P.N. Composite Limited (Extension)

Ambabh, Konabari, Gazipur
(24.020049, 90.321249)
11th & 17th October 2021

Observations

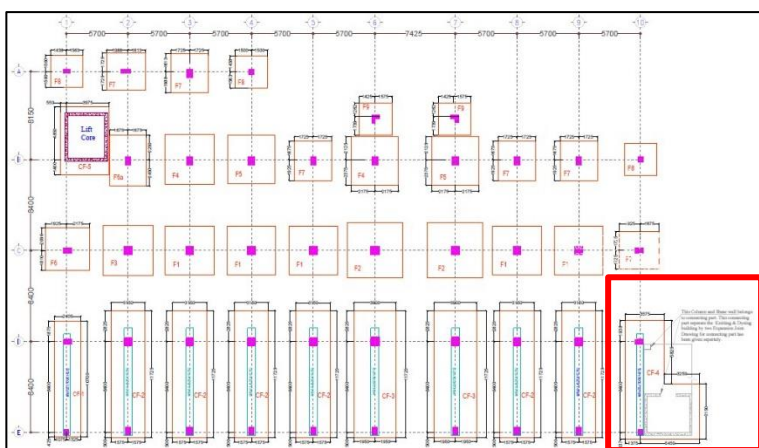
Expansion joints was found among the structures.

1. Expansion joint between connection part and Dyeing building.
2. Expansion joint between Connection part and knitting Building.

Foundation layout plan –Dyeing Building

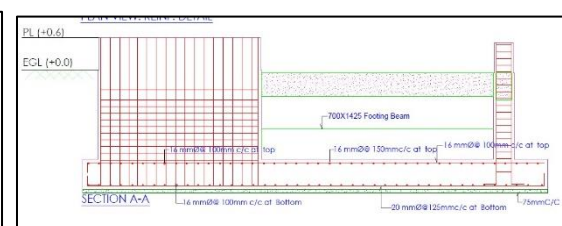
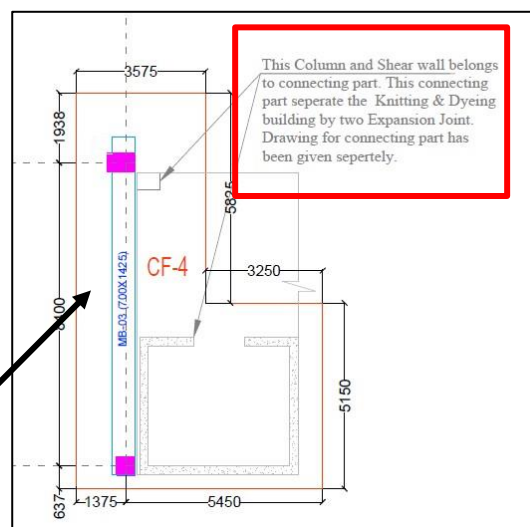
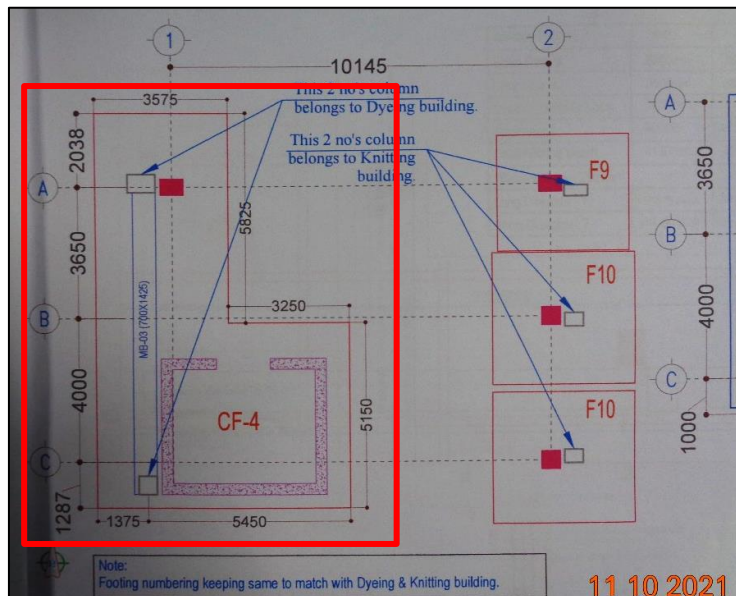
Depth of footing from EGL not shown in the section details of footing. So, this is not clear whether the foundations are overlapping or shearing same footing

The combined footing named “CF4” denoted for both structure but load value found different in adequacy check table.

Sectional Details of the F9 & F10

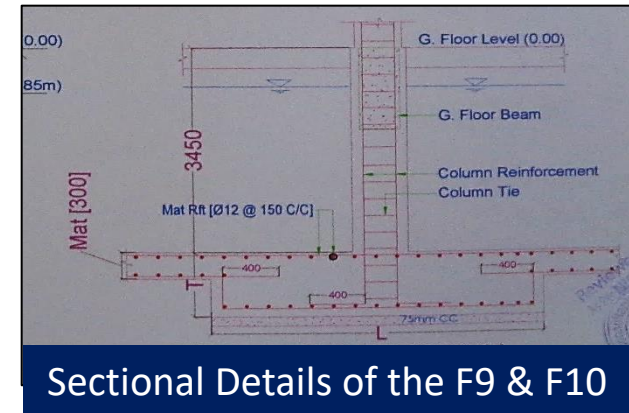
In the foundation adequacy table, capacity of MAT foundation has been shown.

Footing layout plan for the knitting building

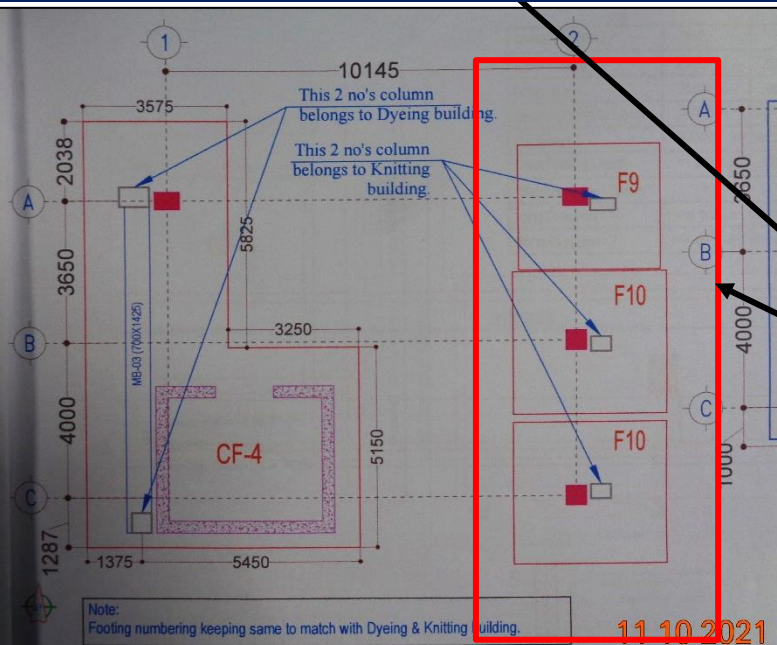
This is not clear whether the foundations of connecting part & knitting building are overlapping or shearing same footing.

Stressed column (yellow marked) in Layout

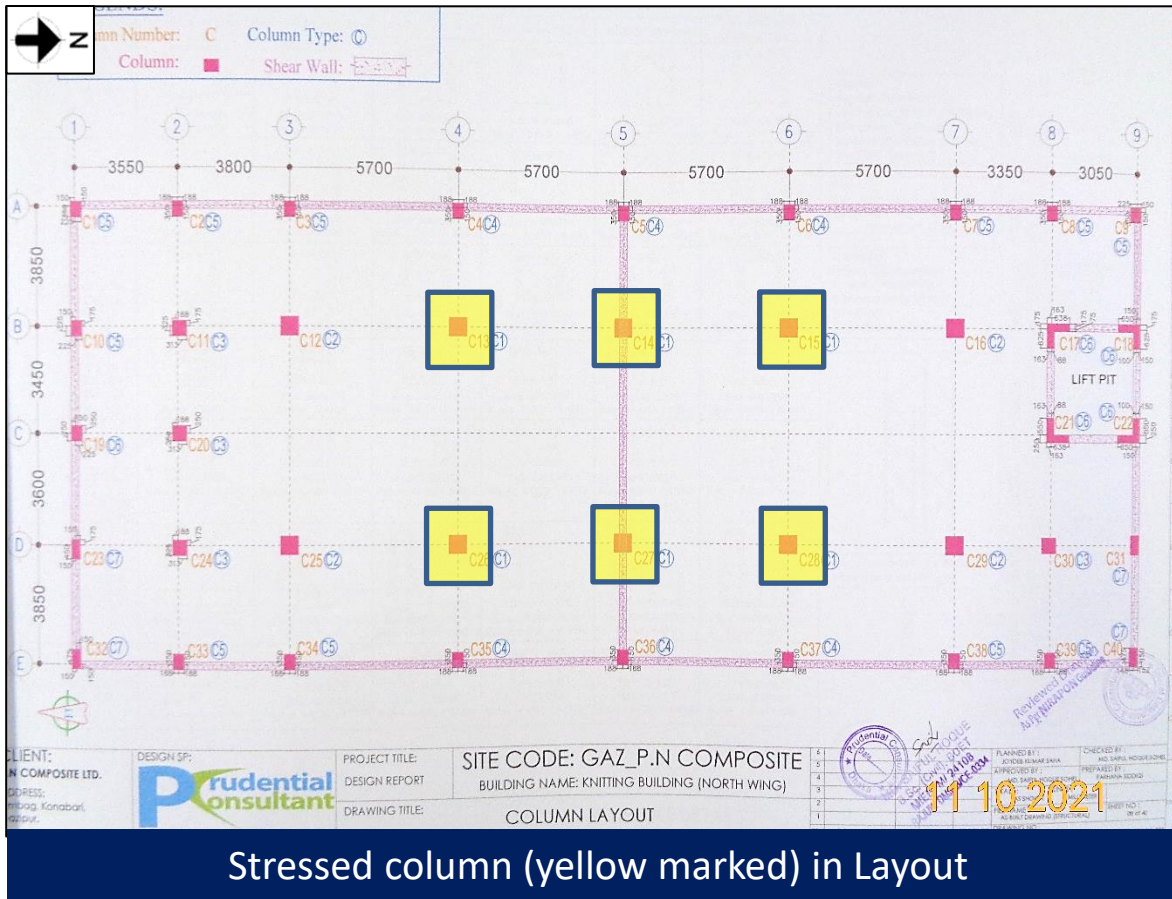
Column to be stressed above normal design limit

Cursory calculation indicates that the working stress of ground floor column slightly exceeds the normal design limit considering the prepared live load 10 KPa on typical floor, 10 kPa on roof top and minimum concrete strength (16.3 MPa) based on aggregate type. Factory is required to verify the in-situ concrete strength of the building and review design, load & column stress for the area identified above

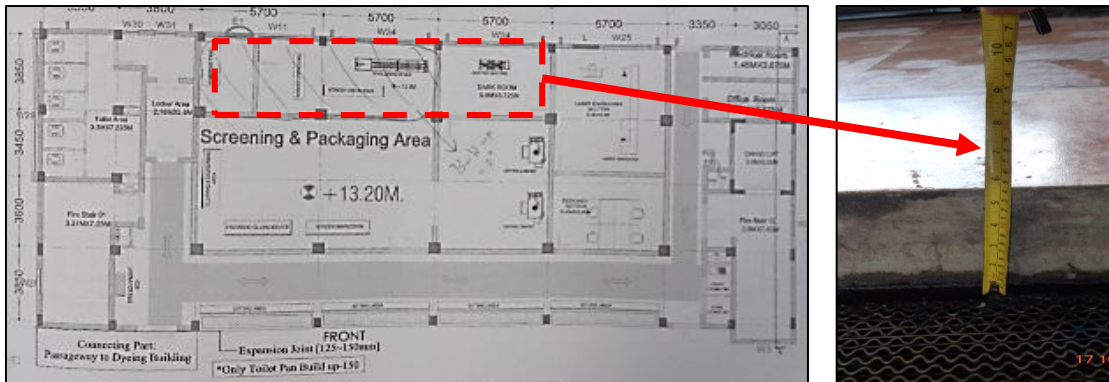
In as-built drawing roof beam was mentioned as 300 mm X 575 mm. Slab thickness in this portion was found 150 mm. But during inspection down stand (d/s) of the roof beam was found 400 mm instead of 425 mm.

During inspection, 50mm build-up was found at 4th floor in screen & packing area. But in as-built drawing no build-up information was mentioned.

Factory engineer is required to update the as-built drawing as per site condition in compliance with section 1.9.1.2 (part-6, BNBC).

Exposed rebar at roof

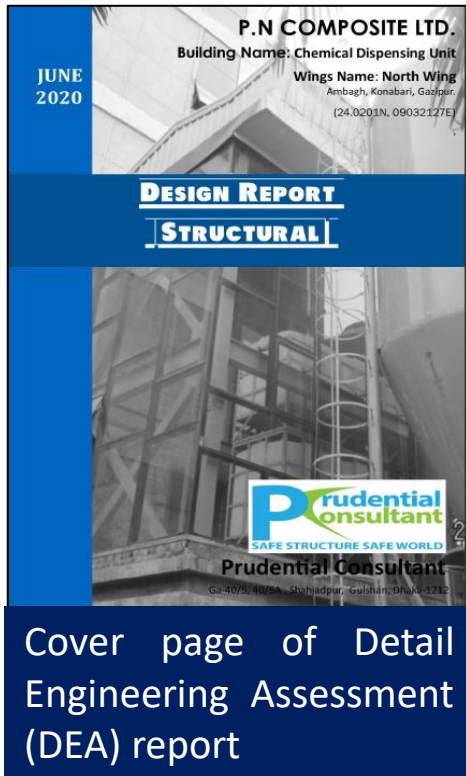
Exposed reinforcement was found at roof which is susceptible to corrosion that may be the cause of deterioration for concrete. Factory engineer is required to take necessary measures to prevent the corrosion in exposed rebar.
